System Impact Assessment Report

Addendum-Final

CAA ID: 2017-614

Project: Nanticoke Solar Project

Figure 2: Nanticoke Solar-New Design

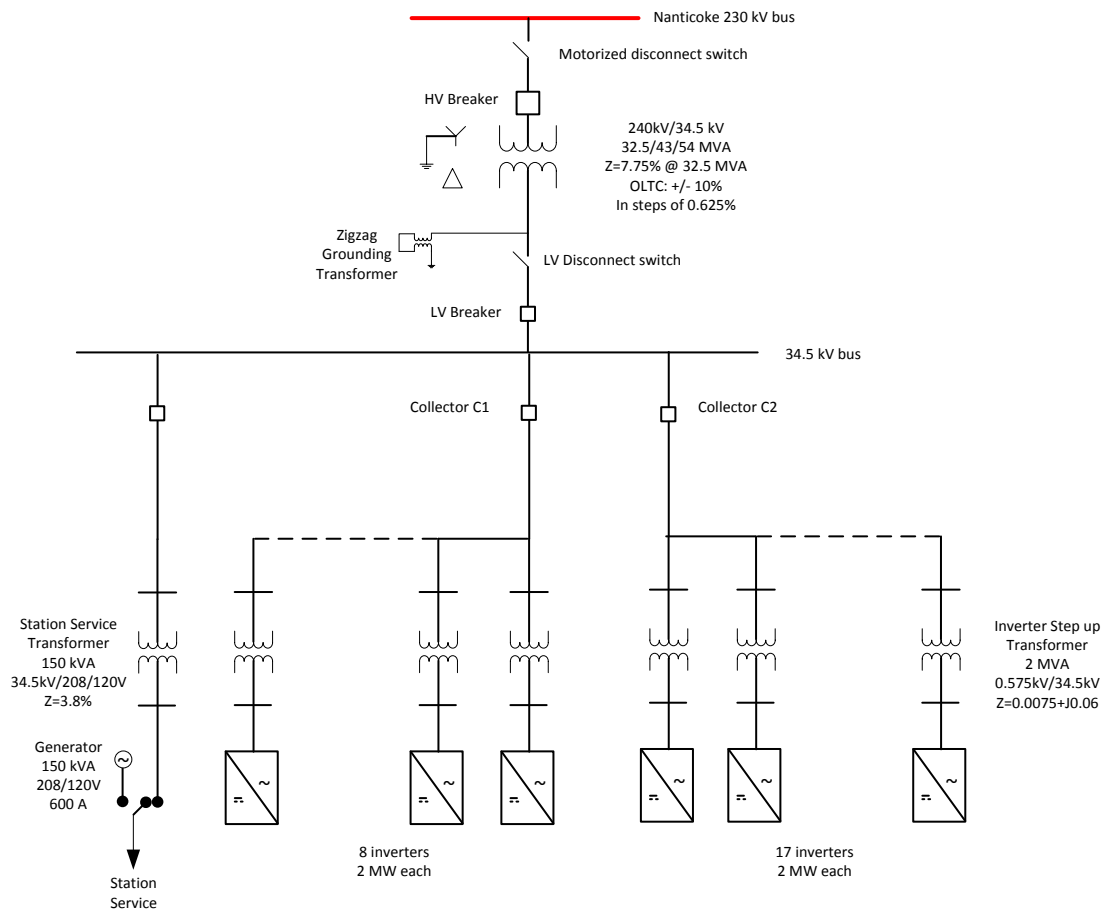
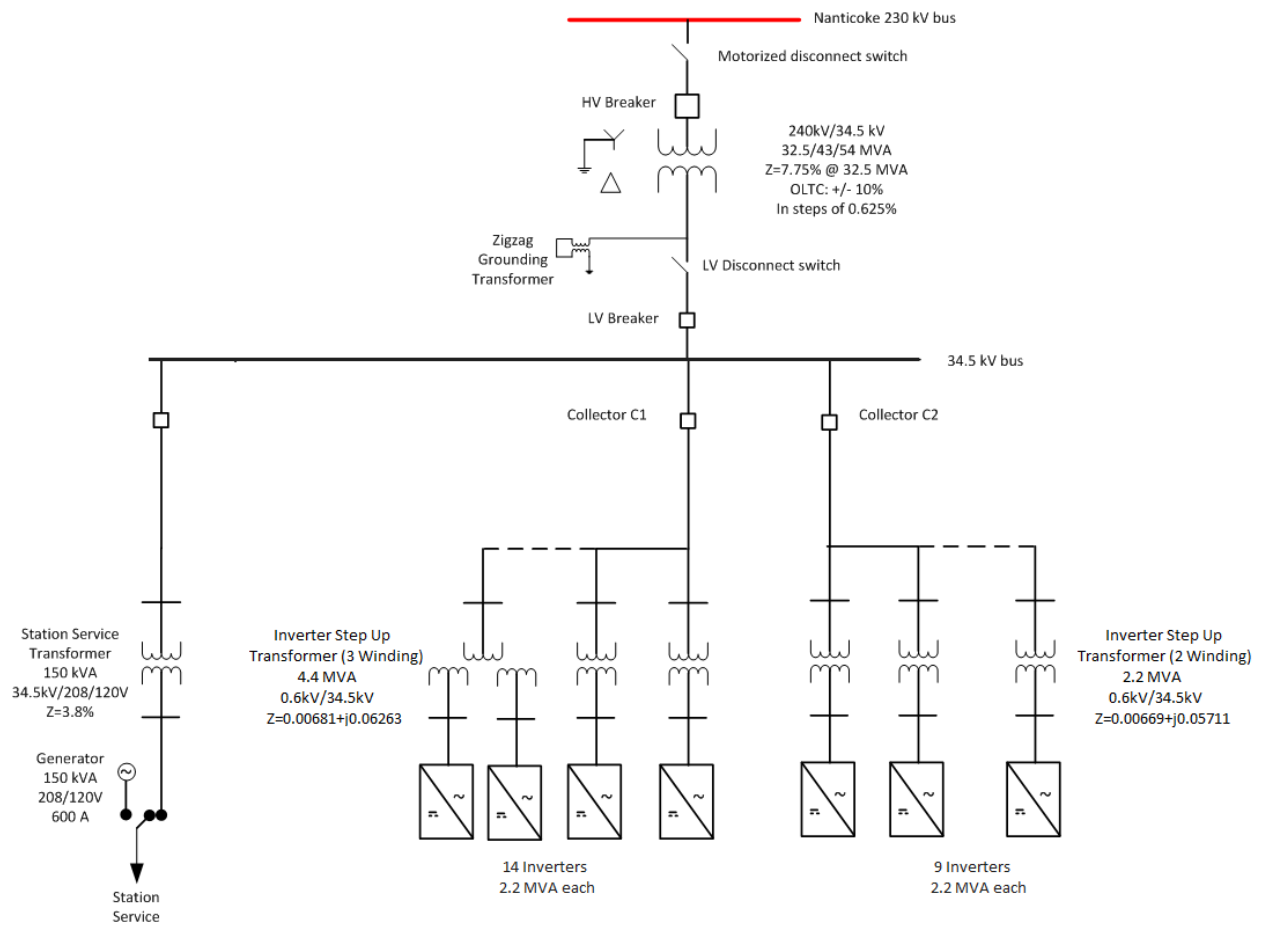
- (4) The proposed inverters have been changed from Conext SmartGen CS 2000 inverters to Conext SmartGen CS 2200 inverters. The new inverters are rated at 2.2 MW each and will be capped at 1.913 MW to limit the project’s total active power injection into the grid to a maximum of 44 MW;
- (5) The collector system has been re-designed to have two collector circuits, C1 and C2, having 14 and 9 PV inverters, respectively;
- (6) The detailed design of the project control system shows; specifically, that voltage will be controlled at the 34.5 kV collector bus without droop.

The single line diagram of the revised project is presented in Figure 2. The project in-service date has also been updated to March, 2019.

The revised connection arrangement of the project shown in Figure 2 will not adversely impact the reliability of the integrated power system and is, therefore, acceptable to the IESO.

Figure 3: Conext SmartGen CS 2200 Variation of Q (Kvar) with P (KW) at Rated Terminal Voltage and 40° C

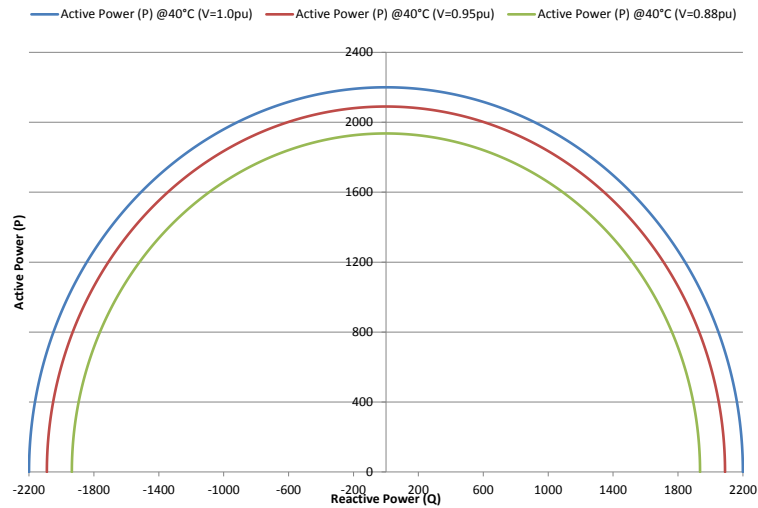
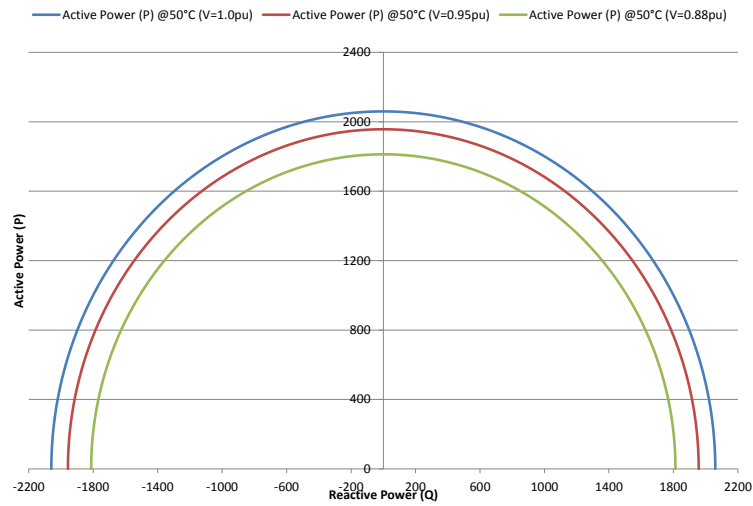
The reactive power capability of the Conext SmartGen CS 2200 PV inverters at the project is dependent on the terminal voltage and ambient temperature. Since each PV inverter is capped at 1.913 MW for active power, the dynamic capability of the inverters was assessed at 1.913MW. The connection applicant provided the reactive power capability of the Conext SmartGen CS2200 PV inverters at ambient temperatures of 40° C and 50° C which are shown in Figure 3 and Figure 4, respectively. The thermal derating graph of these PV inverters is shown in Figure 5.

Table 5 shows the comparison between the Market Rules reactive power requirement and the reactive power capability of the new proposed inverters at a rated terminal voltage of 1.0 pu. It shows the reactive power capability of the inverters cannot meet the Market Rules requirements when the ambient temperature is 50° C.

Figure 5: Thermal De-rating of Conext SmartGen CS 2200 inverters

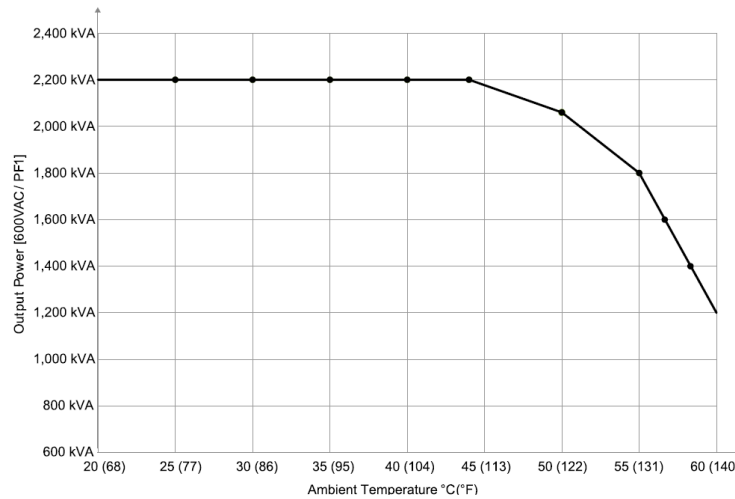
By further investigating the thermal de-rating curve of these inverters as shown in Figure 5, the PV inverters have adequate dynamic reactive power capability at their terminals as long as the ambient temperature is below 43° C. When the ambient temperature increases above 43° C, the MVA rating of the proposed inverters starts to de-rate and their reactive power capability decreases under the same active power output. However, since in Ontario, the probability of the ambient temperature exceeding 43° C is very low, there is no need to install any additional dynamic reactive compensation at the project.

In the future, during the life time of the project, if the ambient temperature exceeds 43° C, the connection applicant will be required to decrease the active power output of the project to a level that supports the reactive power requirements in the Market Rules.

Figure 6: PPC frequency control

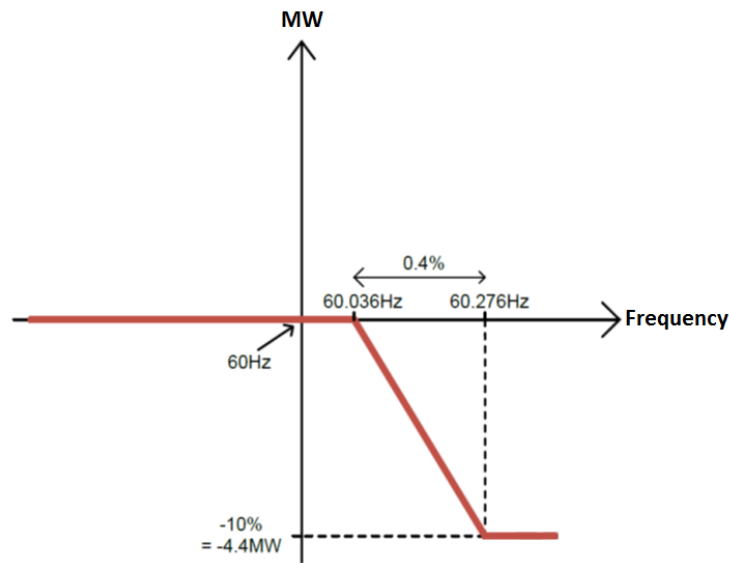
The maximum active power reduction during over-frequency will be set to -10% of the rated active power of the plant (-4.4MW). For a droop set at 4% and a frequency deadband defined at $\pm 0.06\%$ this maximal active power reduction will be reached for frequency over 60.276Hz as shown in Figure 6.
